HISTORIC AND DESIGN REVIEW COMMISSION

HDRC CASE NO: 2020-577
COMMON NAME: 255 BRAHAN
LEGAL DESCRIPTION: NCB 3856 (255 BRAHAN {AMENDING}), BLOCK 2 LOT 26 & 27
ZONING: RM-4, H
CITY COUNCIL DIST.: 2
DISTRICT: Westfort Historic District
APPLICANT: Cy Goudge/JCG Homes, LLC
OWNER: OCP JCG Westfort, LLC
TYPE OF WORK: New construction
APPLICATION RECEIVED: December 21, 2020
60-DAY REVIEW: Not applicable due to City Council Emergency Orders
CASE MANAGER: Edward Hall

Historic and Design Review Commission
Design Review Committee Report

HDRC Case #: 2020-577

CONCEPTUAL SITE PLAN

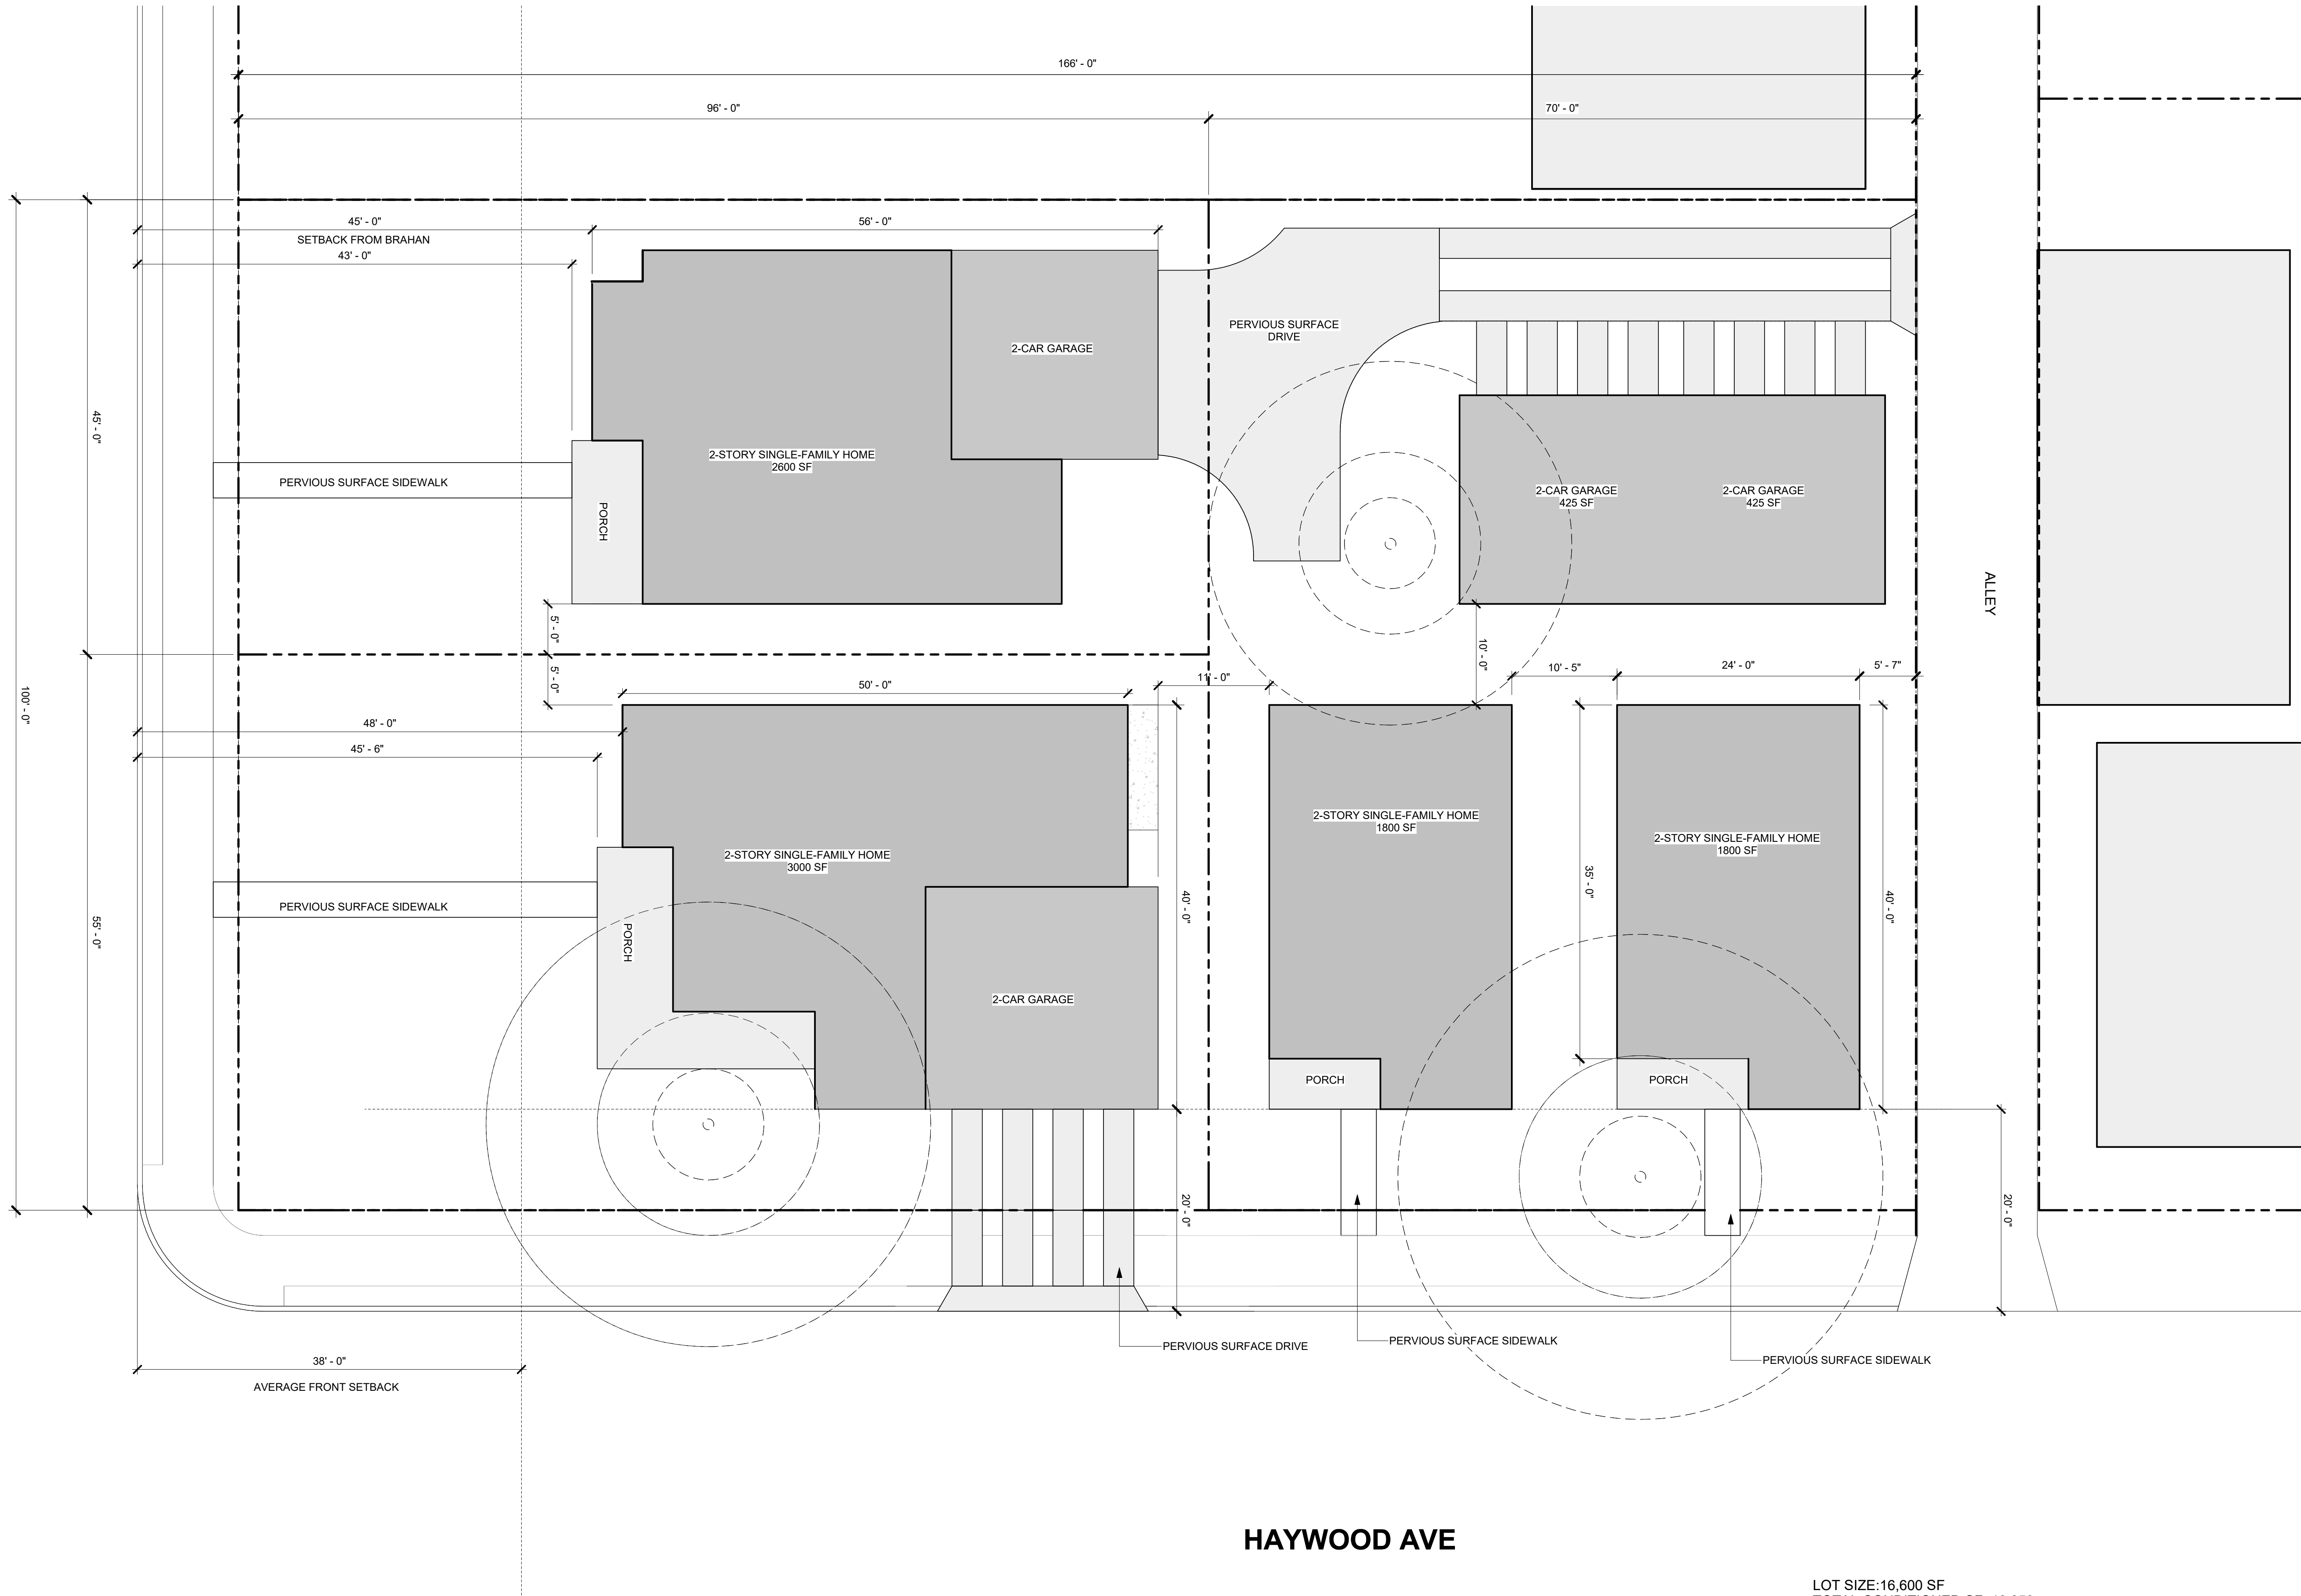
- f. **SETBACKS (Brahan)** – The applicant has proposed for the structure facing Brahan to feature setbacks of approximately forty-three (43) and forty-five (45) feet from the street. The applicant has provided a setback

diagram noting that both structures will feature setbacks that are greater than the two historic structure's setbacks to the immediate west. Generally staff finds the proposed setbacks for Brahan to be appropriate and consistent with the Guidelines.

- g. **SETBACKS (Haywood)** – The applicant has proposed setbacks of twenty (20) feet from the right of way on Haywood. This setback is greater than the adjacent historic structure's setback to Haywood. Generally, staff finds the proposed setbacks on Haywood to be appropriate and consistent with the Guidelines.

- h. **LOT COVERAGE** – Per the Guidelines for New Construction 2.D.i., applicants should limit the building footprint for new construction to no more than 50 percent of the total lot area, unless adjacent historic buildings establish a precedent with a greater building to lot ratio. The applicant has noted that the percentage of impervious cover from building footprints is approximately thirty-nine (39) percent of the lot. This is consistent with the Guidelines.

- q. **DRIVEWAY** – The applicant has proposed a double width driveway on Haywood and a single width driveway at the rear alley. Generally staff finds the locations of the proposed driveways to be appropriate; however, staff finds that the proposed driveways on Haywood should be designed to appear as two separate driveway elements, to be separated by landscaping elements. Each driveway should not exceed ten (10) feet in width.

JF: Not too concerned about one large curb cut on Haywood. Recommends that the garage door on Haywood be separated to be consistent with examples found in the neighborhood. Not as much concern about double width garage doors on interior elevations (AMG in agreement). Include windows in top panel of garage doors.

AMG: If an alternative to the ribbon driveway can be found, it would be appropriate (CG – will propose an alternative).

AMG: Outside of driveways, no issue with site configuration.

- iv. That the proposed driveways on Haywood be separated by a landscaping element (as to read as two separate driveways), that no driveway exceed ten (10) feet in height, and that garage doors feature single widths, metal construction and windows.
